## Addendum / Addenda

Project Description / Description de projet M58 Roof Replacement area 1,5,8		
Solicitation No./N° de sollicitation 18-22122	Project No./N° de projet 5398	W.O. No./N° d'ordre de travail number
Departmental Representative / représentant ministériel Sylvain Thibodeau		Date March 22, 2019
<b>Notice:</b> This addendum shall form part of the tender documents and all conditions shall apply and be read in conjunction with the original plans and specifications.		<b>Nota:</b> Cet addenda fait partie intégrale des dossiers d'appel; toutes les conditions énoncées doivent être lues et appliquées en conjonction avec les plans et les devis originaux.

M58-5397-SK01

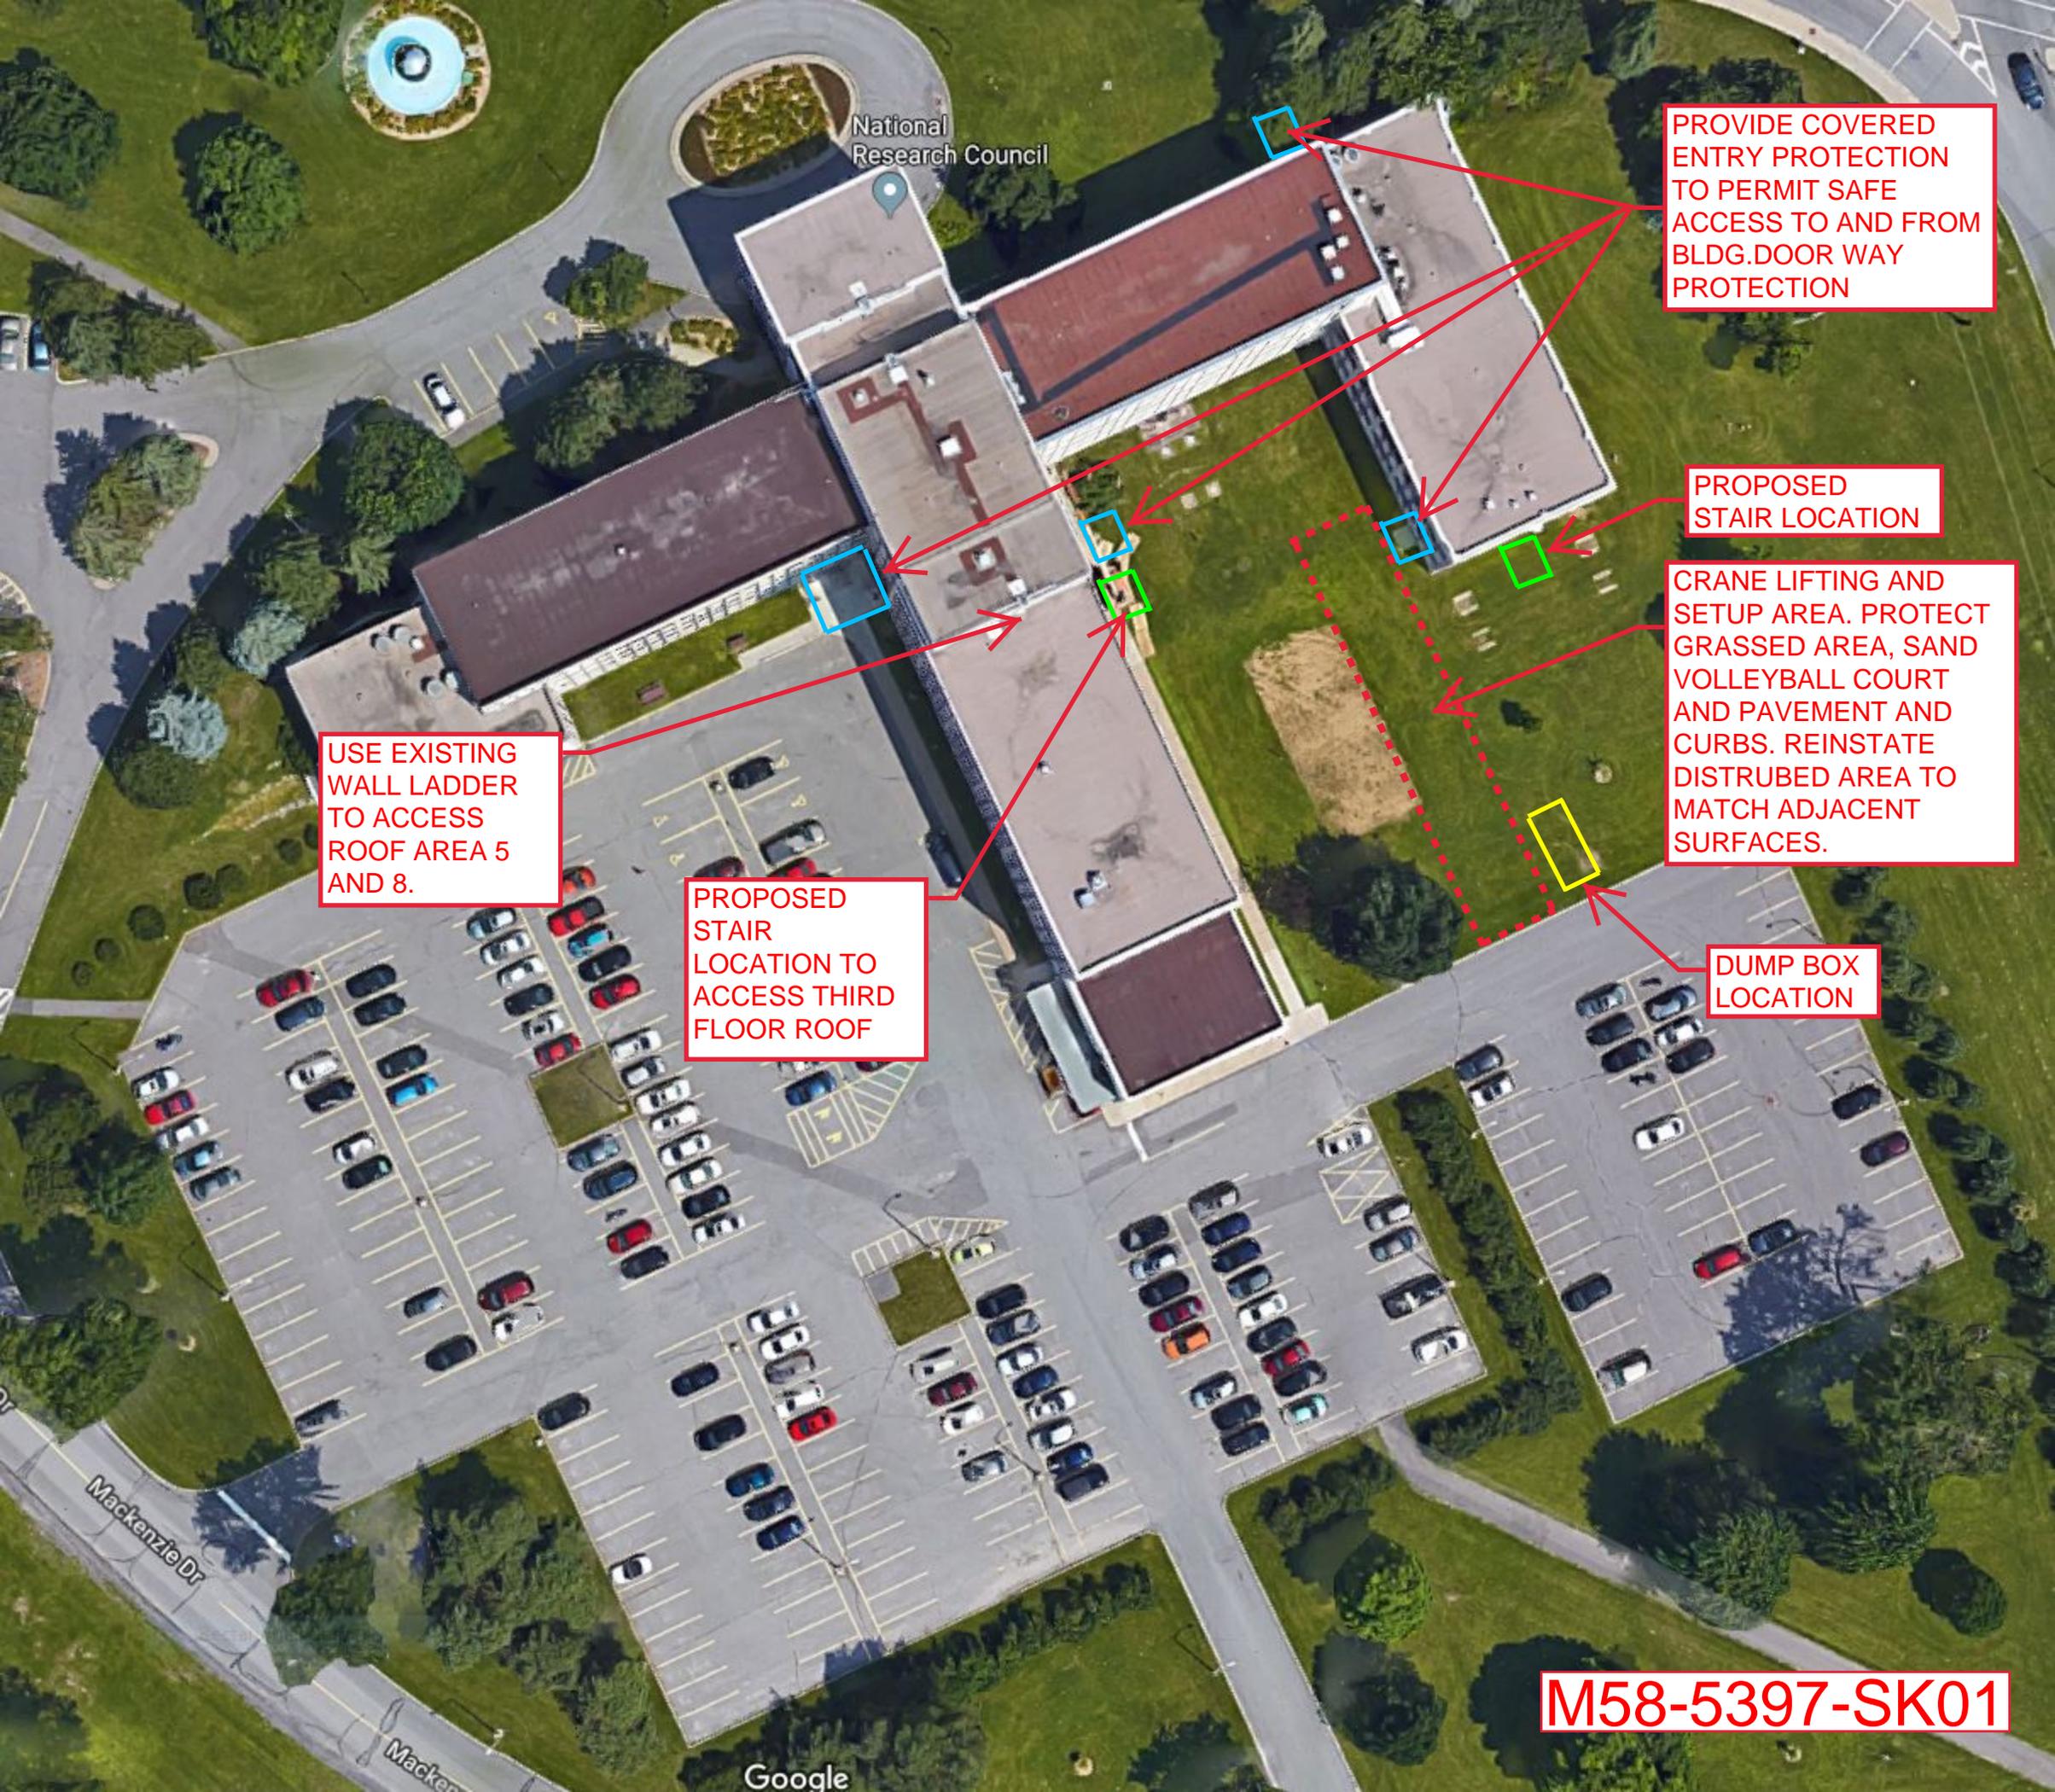
At the job showing no one knew of the designated set-up areas for garbage bins, craning etc....I was told to submit this too you and an addendum would be sent out to clarify where we are to set-up for the different roof areas.

Answer: **Please refer to attached drawing for location of refuse bin, entry protections, crane lifting area, stair location for roof 1 and stair location for roof 5,8**

PROVIDE COVERED ENTRY PROTECTION TO PERMIT SAFE ACCESS TO AND FROM BLDG.DOR WAY PROTECTION

PROPOSED STAIR LOCATION

CRANE LIFTING AND SETUP AREA. PROTECT GRASSED AREA, SAND VOLLEYBALL COURT AND PAVEMENT AND CURBS. REINSTATE DISTRUBED AREA TO MATCH ADJACENT SURFACES.

USE EXISTING WALL LADDER TO ACCESS ROOF AREA 5 AND 8.

PROPOSED STAIR LOCATION TO ACCESS THIRD FLOOR ROOF

DUMP BOX LOCATION
